Service Letter No. 213

SUBJECT: Primer Lines

MODELS AFFECTED: All PA-18, PA-20 and PA-22 Airplanes

PA-18 (LYCOMING ENGINE)

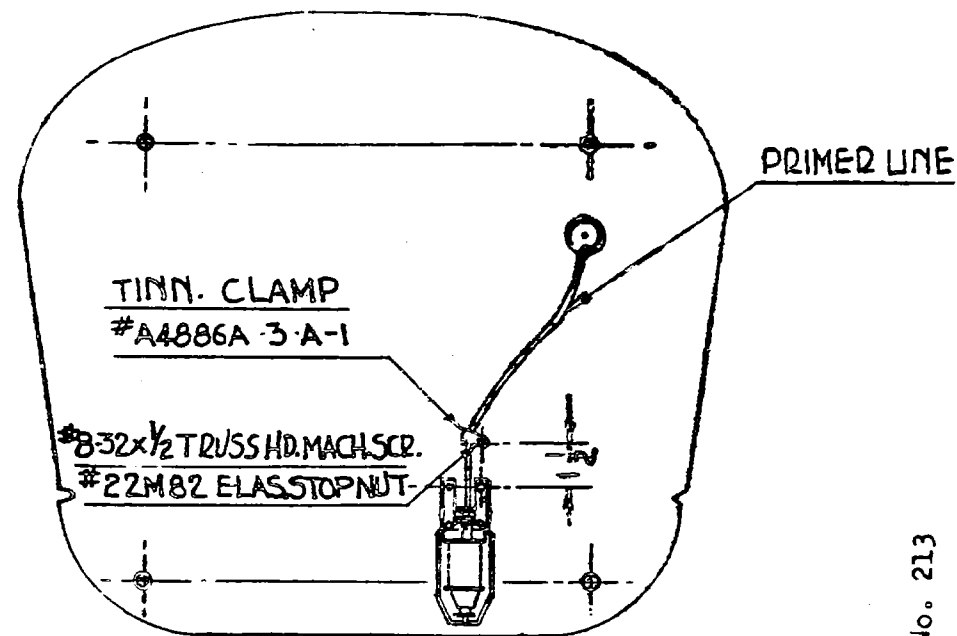
It has been brought to our attention by our field organization and by the Civil Aeronautics Authority that the primer line which runs adjacent to the firewall had, because of vibration, rubbed against the firewall and muffler and had worn through to such an extent that gasoline leaked out and seeped through the firewall onto the floorboards and carpet.

In order to prevent possible occurrences of this type in other airplanes it is recommended that the primer lines on all of the above model aircraft be clamped and/or re-routed per the sketch on the reverse side of this letter.

There is one (1) Tinnerman clamp number A4886A-3-A-1 required on the PA-18. There is one (1) Tinnerman clamp number A4886A-3-A-1 and one (1) 80032-51 clamp required on the PA-20's and PA-22's. These clamps will be furnished No Charge and they may be obtained through the Piper Distributor in your area.

WRAP PRIMER LINE WITH FRICTION
TAPE UNDER ATTACHMENT CLAMP TO
PROVIDE SNUG FIT.
